Mission Valley Community Plan Update

FINAL PROGRAM ENVIRONMENTAL

SCH# 2017071066 | MAY 31, 2019

Mission Valley Community Plan Update Final Program Environmental Impact Report San Diego, California

Figure 3.3-1: Proposed Land Use Diagram

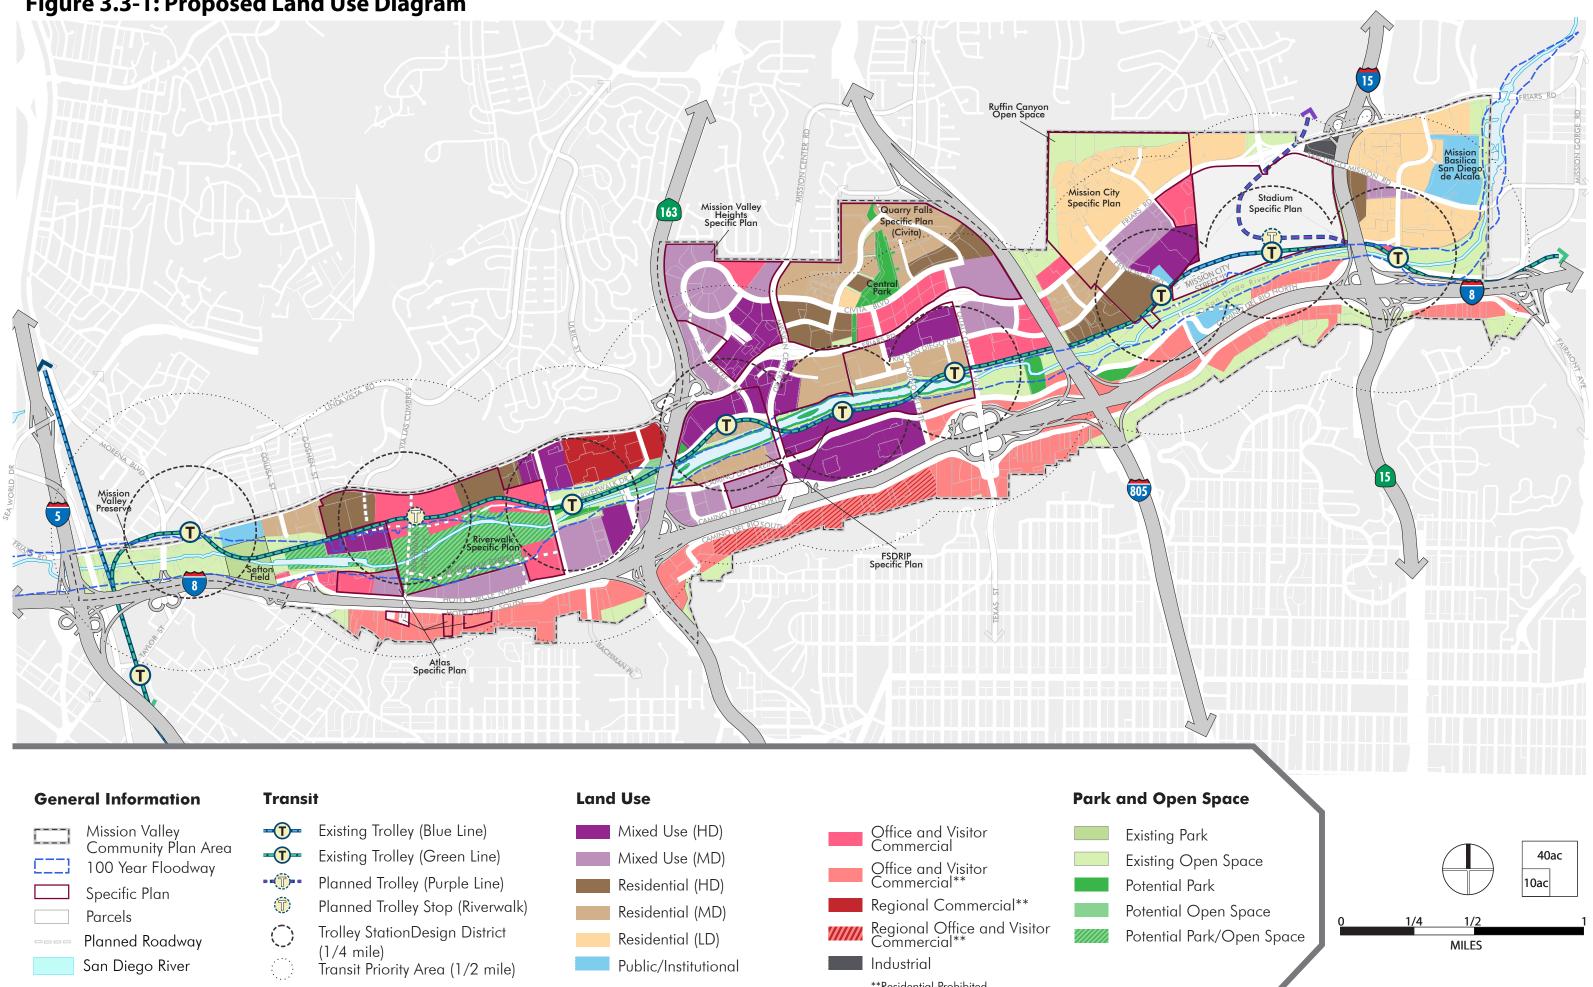
Figure 4 of the Draft Update depicts the entire Mission Valley East site as Mixed Use (High Density). However, Figure 3.3-1 of the DPEIR depicts Regional Retail in the center and Mixed Use (High Density) on the east and west edges of the Mission Valley East property. We request that this inconsistency be corrected, and that the DPEIR designations be carried forward in the Draft Update.

The Draft Update and the DPEIR also do not provide sufficient detail about the potential zones that would be applied within each of the land use designations depicted in Figure 4 of the Draft Update and Figure 3.3-1 of the DPEIR. We request further clarification of the intended zones that would be potentially applicable within each of the land use designations—and in particular, within the Regional Retail and Mixed Use (High Density) zones.

Figure 4.13-3: Existing and Planned Bicycle Network

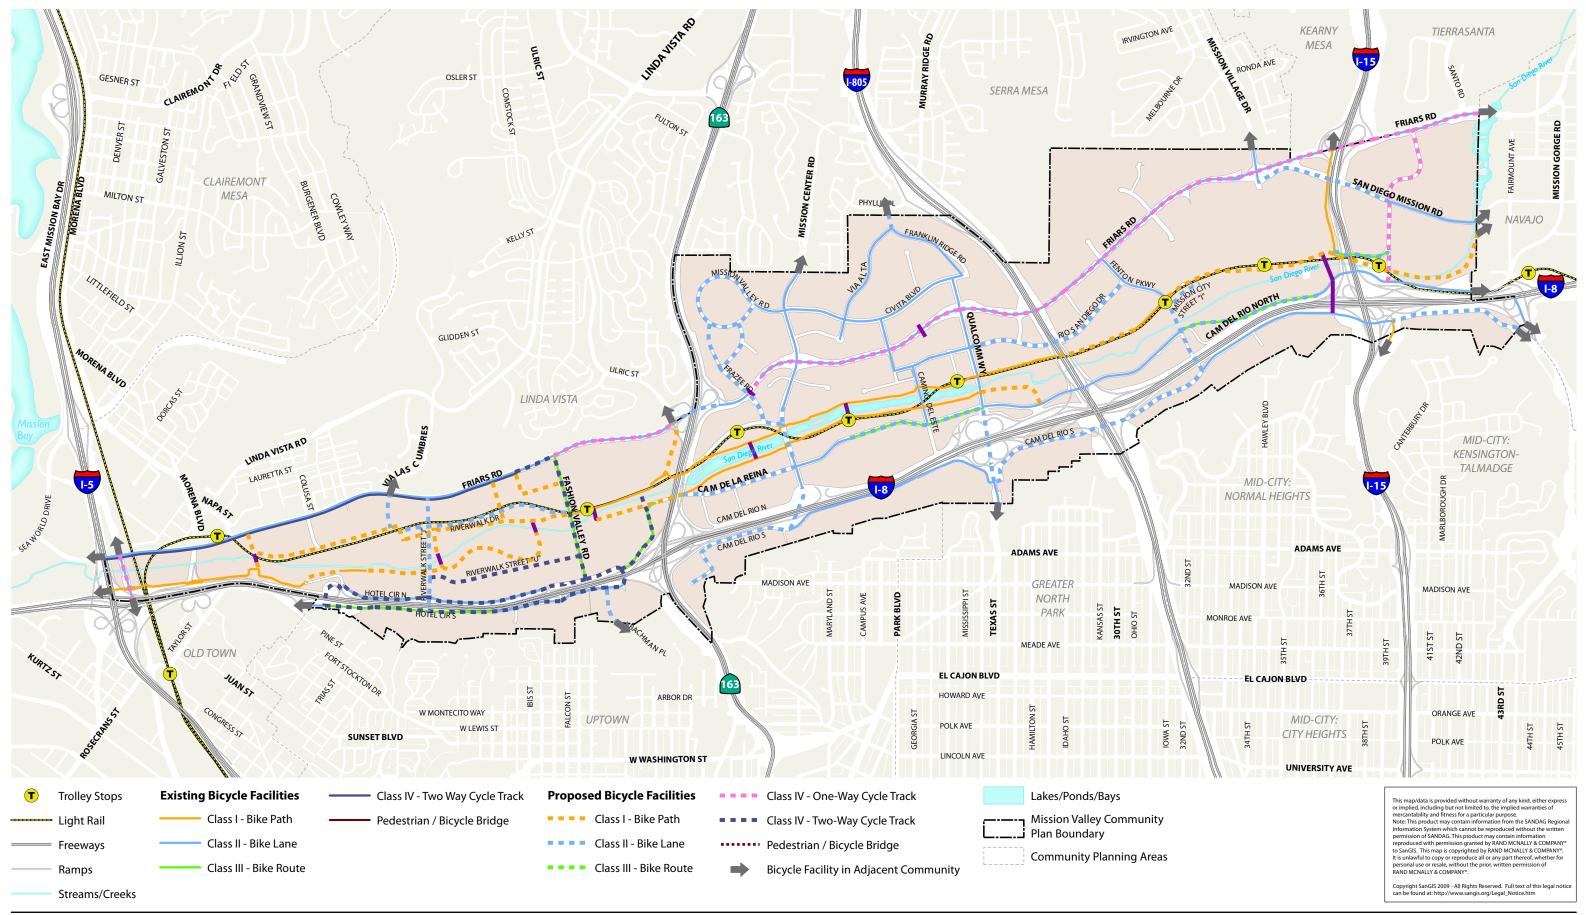
Figure 4.13-3: Existing and Planned Bicycle Network shows planned Class I, Class II, and Class IV bicycle facilities that will cross through Caltrans right-of-way. The City should plan to coordinate early in the project development process with Caltrans District 11 Planning to navigate the Caltrans encroachment permit process for the bicycle network projects. Furthermore, the following Caltrans documents should be utilized to design the bicycle facilities through Caltrans right-of-way.

Figure 4.13-4: Proposed CPU Roadway Network

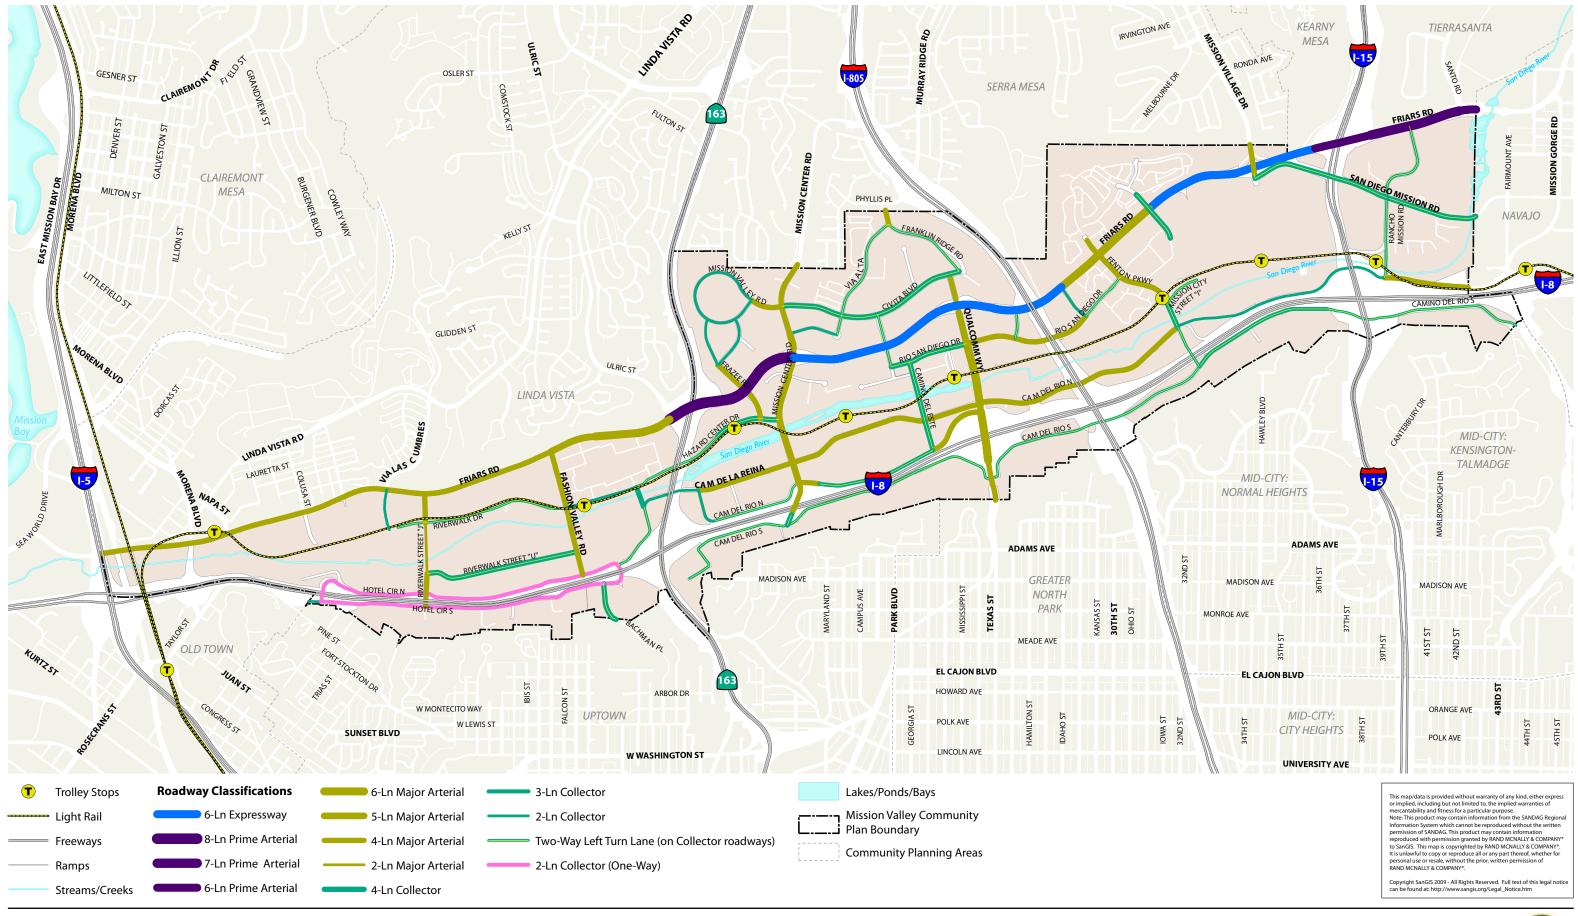
On Figure 4.13-4 CPU Roadway Network, New Street "J" appears to first start as 4 Lane Major from Friars to Riverwalk Drive, then become 2 Lane Major from Riverwalk Drive to Levi Cushman Street "B", then return to a 4 Lane Major from Levi Cushman Street "B" to Hotel Circle South. However, Street "J" was previously represented to be a 2 Lane Major from end to end. The graphic is not accurate or consistent. Please correct the graphics accordingly.

Figure 4.13-5: Planned Transit Facilities

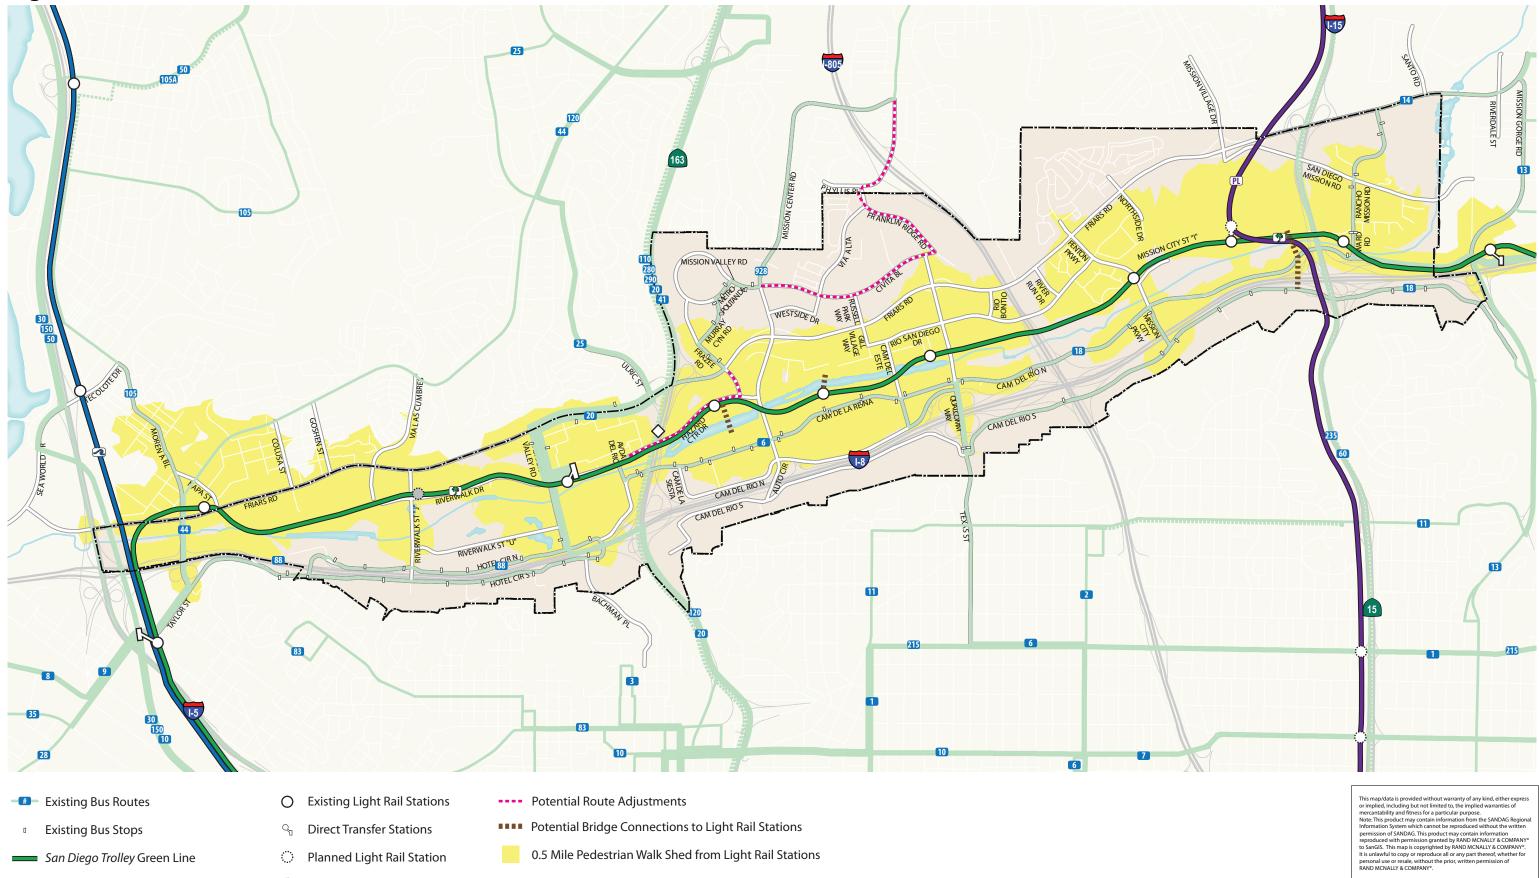
4. <u>Planned Trolley Purple Line</u>. The MVCPU Draft EIR states that the SANDAG Regional Plan's planned Purple Line Trolley would provide a new north-south transit connection through the Stadium site and generally would parallel I-15. The MVCPU Draft EIR also states that the exact alignment of the Purple Line Trolley is not known at this time. (MVCPU Draft EIR, p. 4.9-39.) Figure 4.13-5, Planned Transit Facilities, shows a planned trolley Purple Line bisecting the Stadium site. (MVCPU Draft EIR, p. 4.13-49.) SDSU could accommodate the Purple Line as shown on Figure 4.13-5, but it has a strong preference for there to be a second alignment option. For purposes of transit ridership, cost, and minimizing impacts to the River Park, the best location and alignment for the planned Purple Line is adjacent to, and parallel with, the I-15. Please realign the Purple Line shown in MVCPU and its Draft EIR, so that it is adjacent to, and parallel with, I-15. Alternatively, at a minimum, please revise the MVCPU and its Draft EIR to reflect one or more proposed alignments, including the alignment proposed in this comment. A4-4

- A4-6 PEIR Figure 4.13-5 illustrates a proposed purple line as identified in SANDAG's Regional Plan (2015). It is correct to state that while the purple line would run through the Stadium site, the exact alignment is not presently known. The PEIR analysis of future noise impacts considers that because the alignment is unknown, impacts are significant and unavoidable. Consistent with the PEIR mitigation framework, future discretionary review of the Stadium project would provide supplemental CEQA analysis to disclose the specific alignment of the trolley line, analyze impacts, and identify appropriate mitigation measures.
